Subject: Bangor Savings Bank

Windham Branch/Office Parking Expansion Response to Staff Review Comments

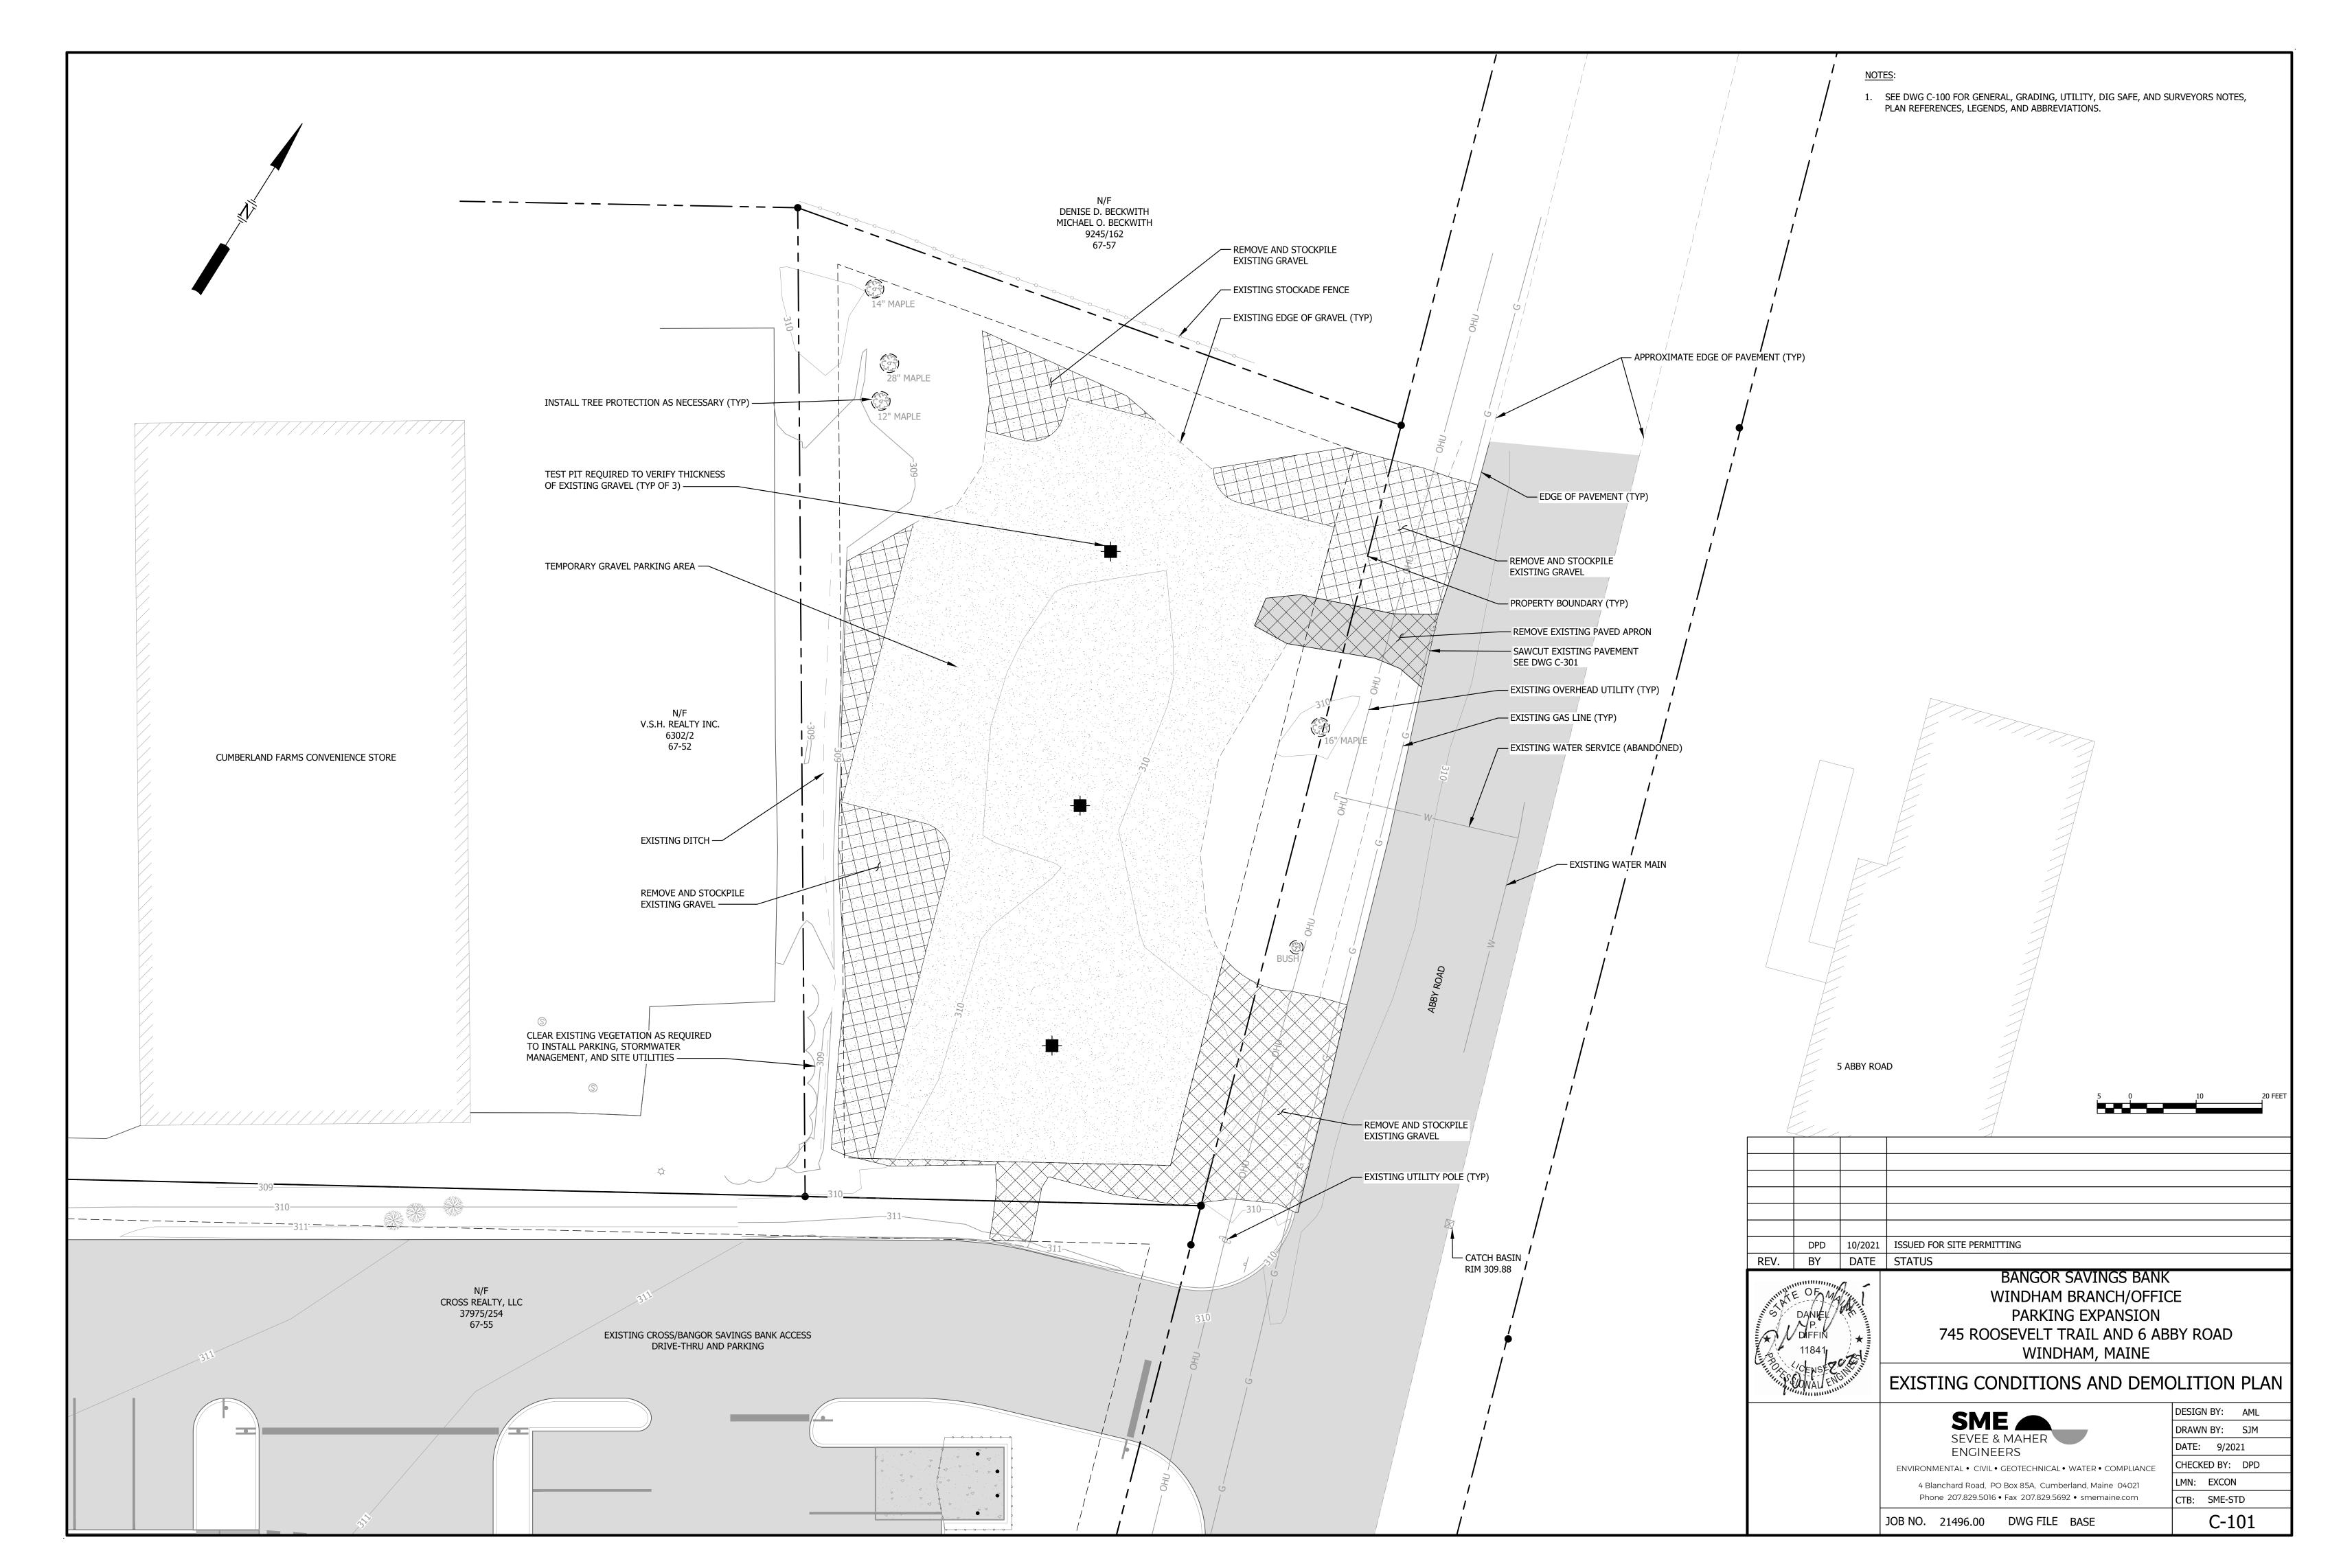
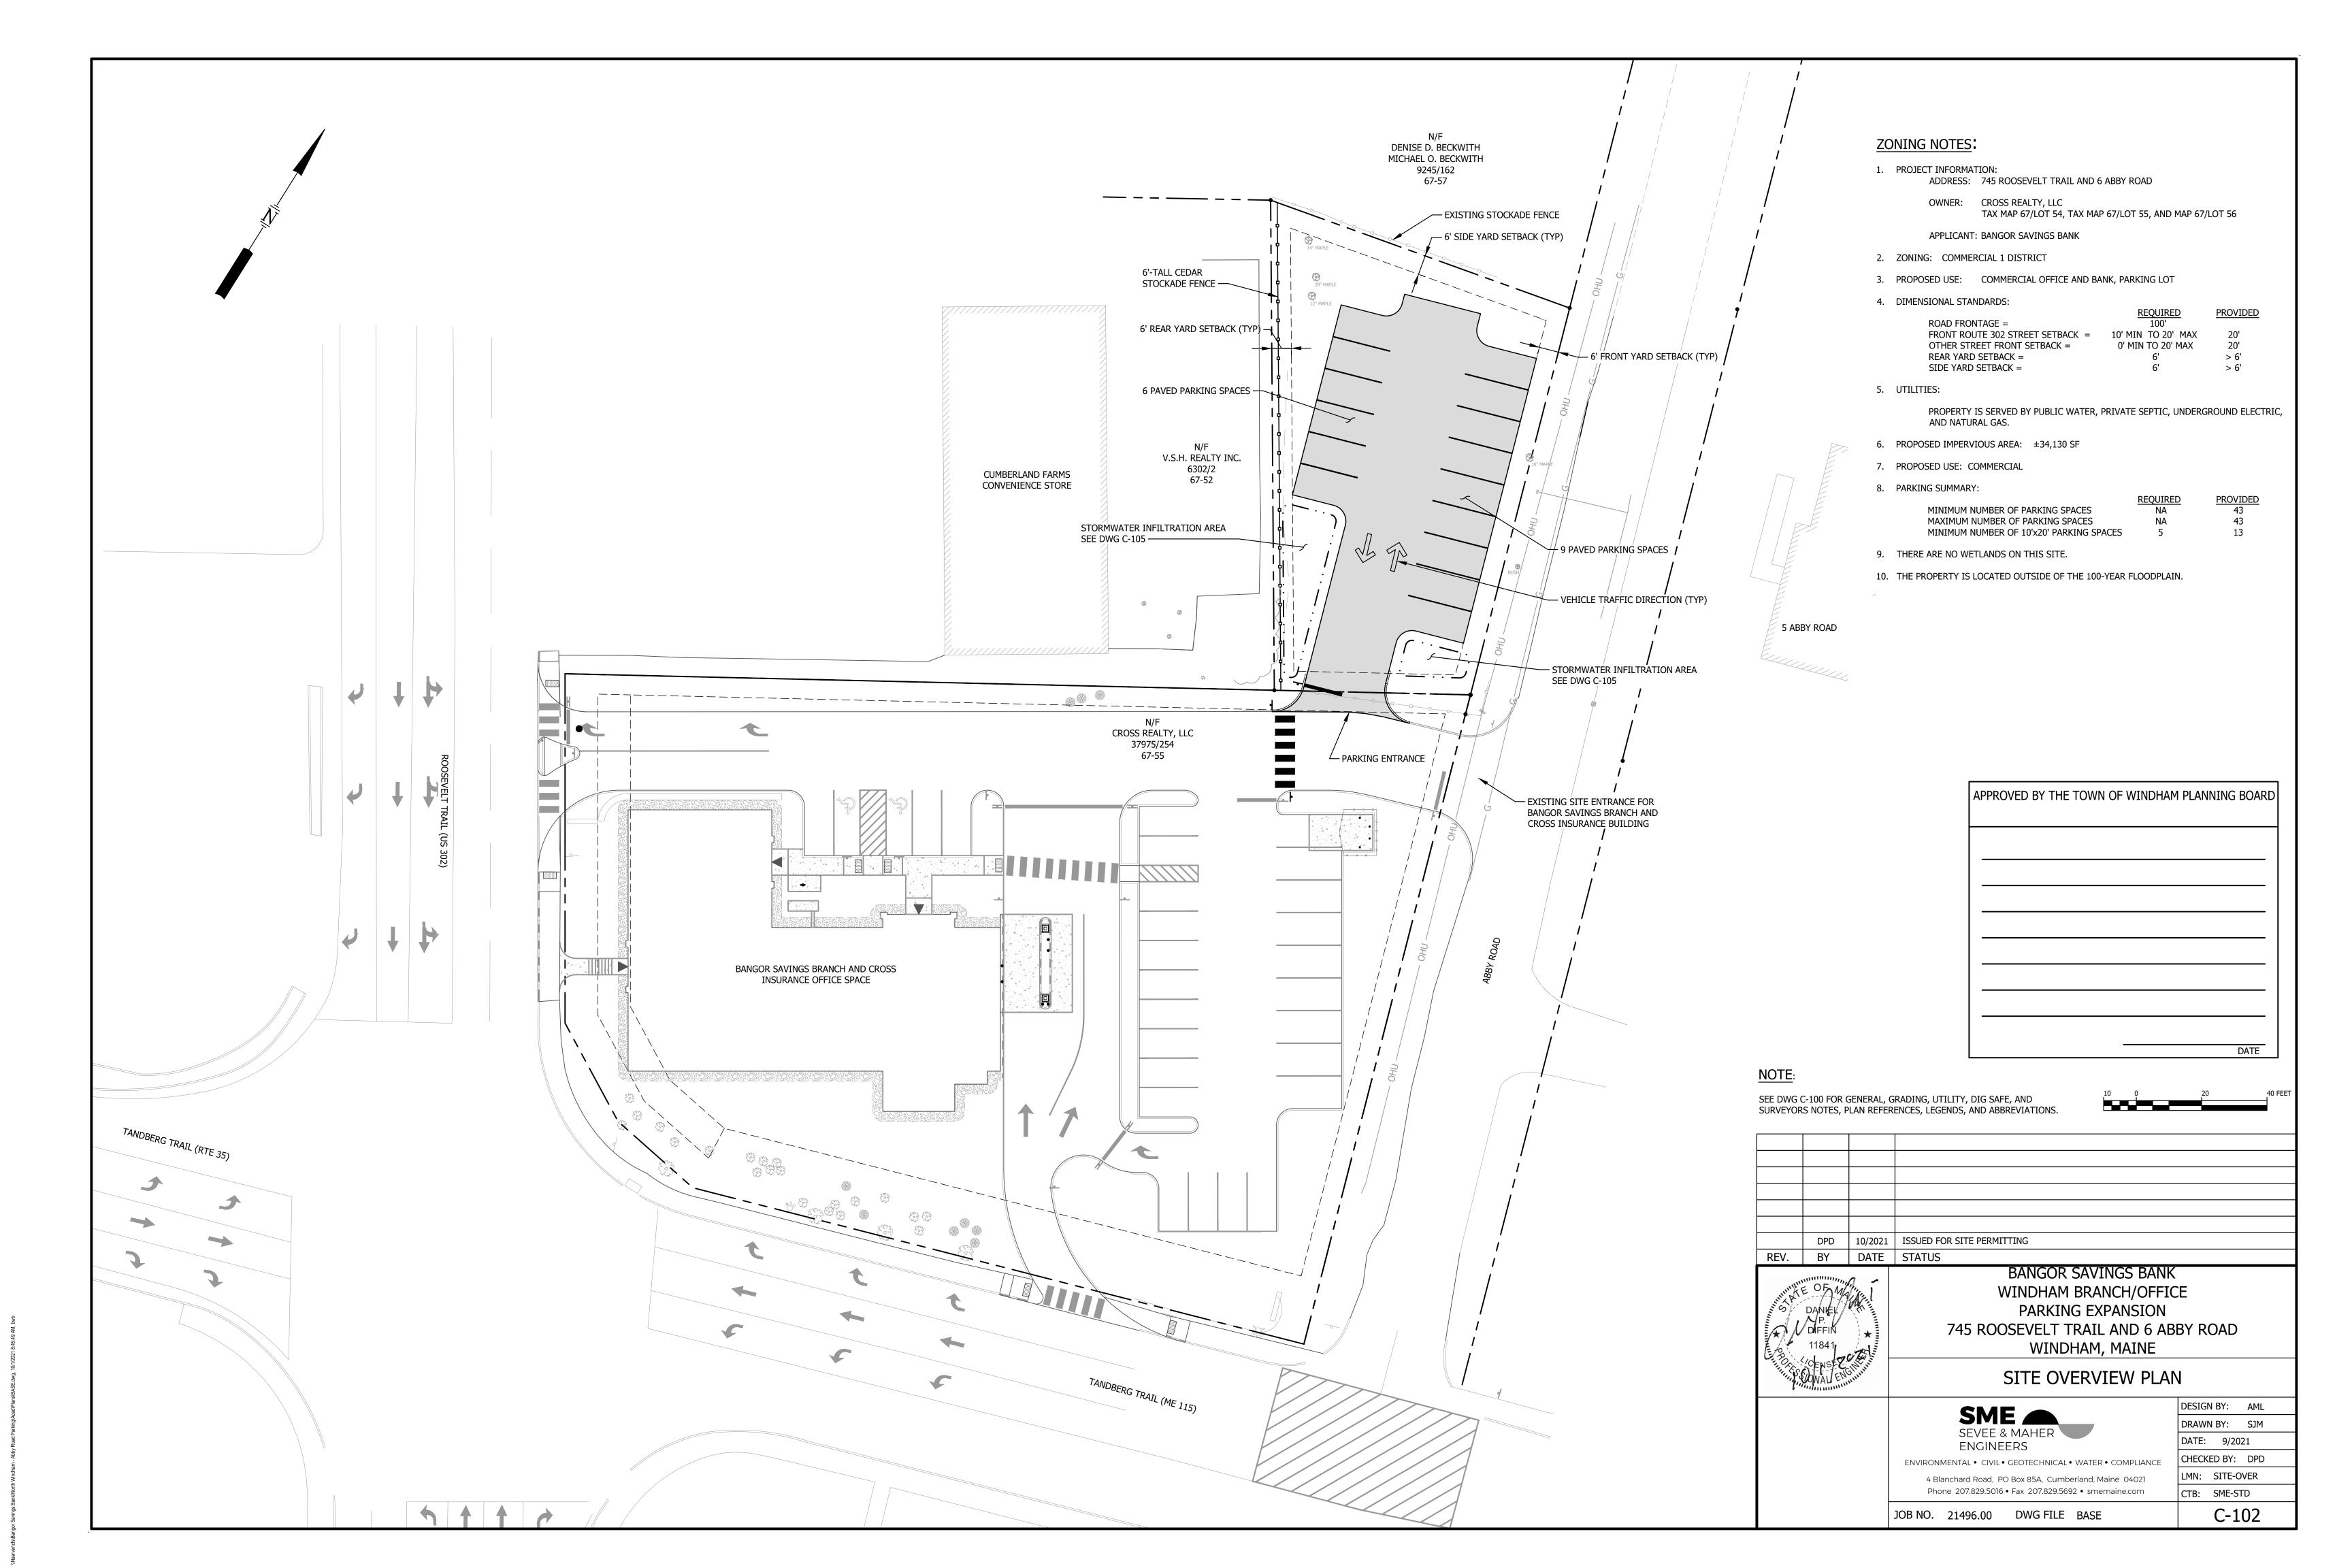
4. Please add "Amended" in the title block of Sheet C-102.

9. Please add the following

<u>SME Response</u>: Project plans have been updated to include "Amended" on Sheet C-102. A copy of the updated plan set is attached for reference.

<u>SME Response</u>: The Conditions of Approval were added to Sheet C-102. A copy of the updated plan set is attached for reference.
